Detailed Site Plan

Salubria Center

DSP-23015

STAFF REPORT

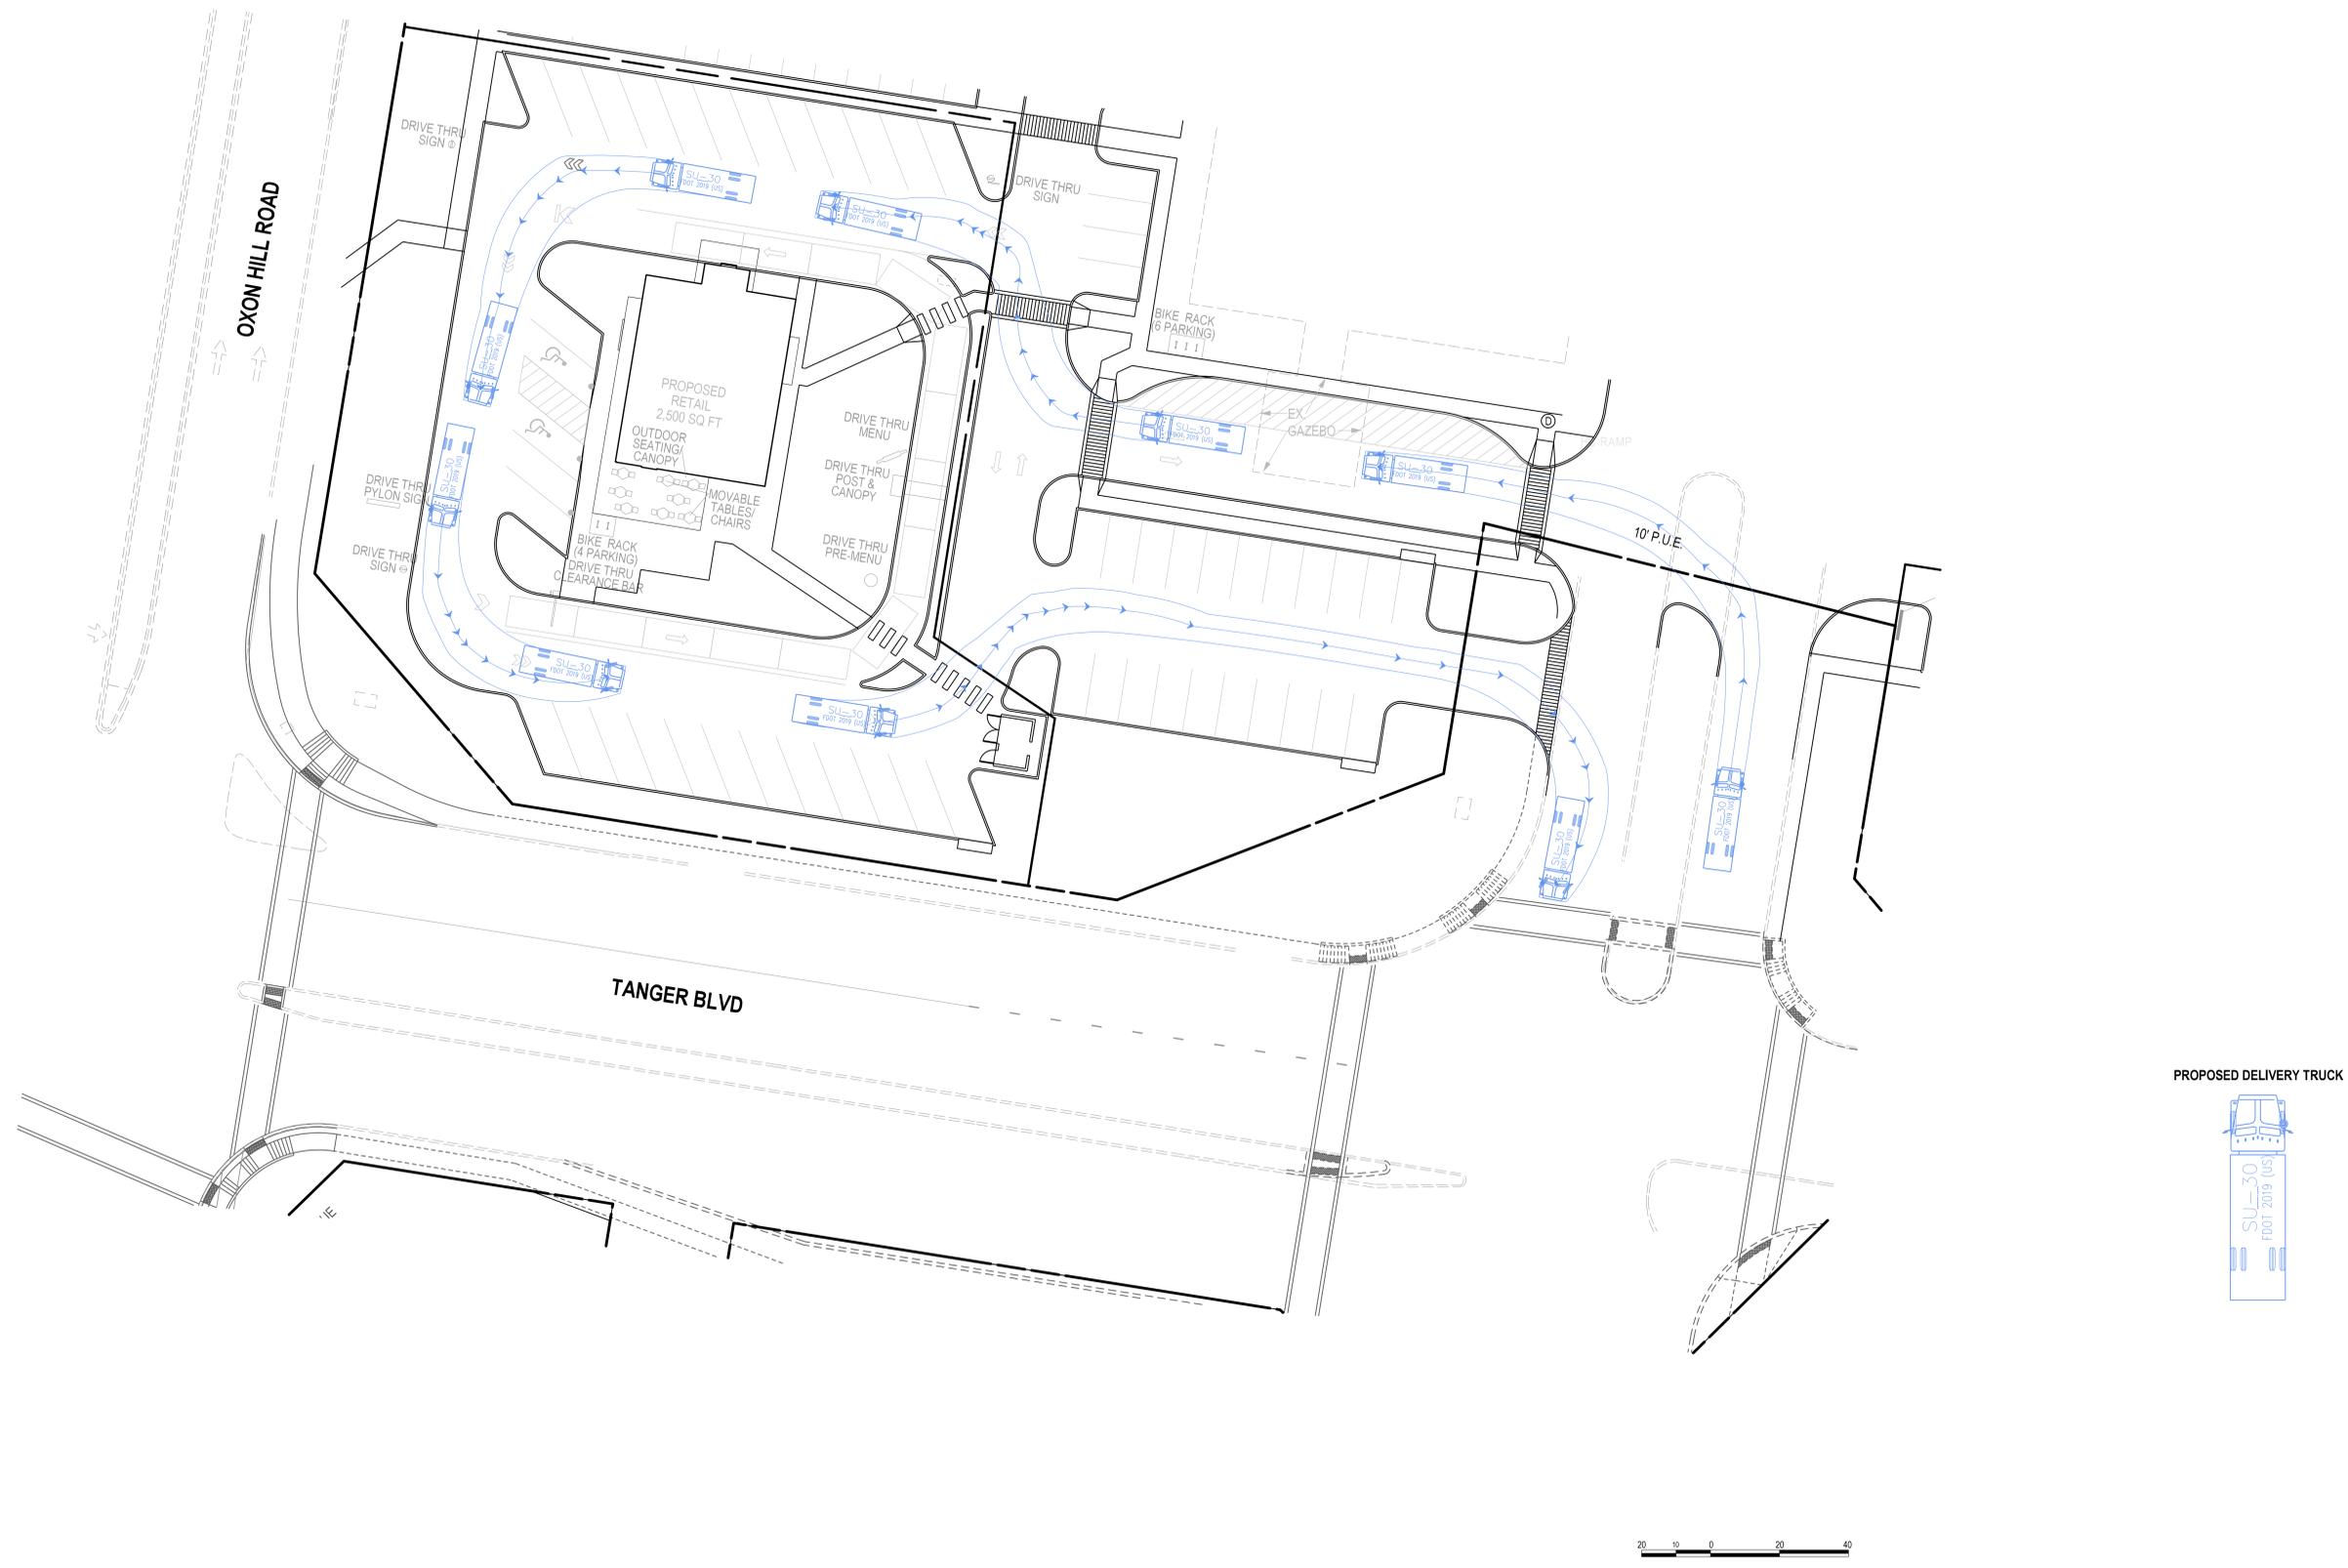
Comment 2: Please provide the location of any proposed fire department connections (FDC's.) A hydrant must be provided within 200' of all FDC's measured as hose is laid by the fire department in accordance with Prince George's County Subtitle 4-167.

Response: **The FDC's are for the new buildings are not finalized yet. The daycare FDC will most likely be located on the front of the building. And the Eating and Drinking Establishment FDC will most likely be located on the south or west side of the building. At the time of permit, the FDC's will be within 200ft of all hydrants.**
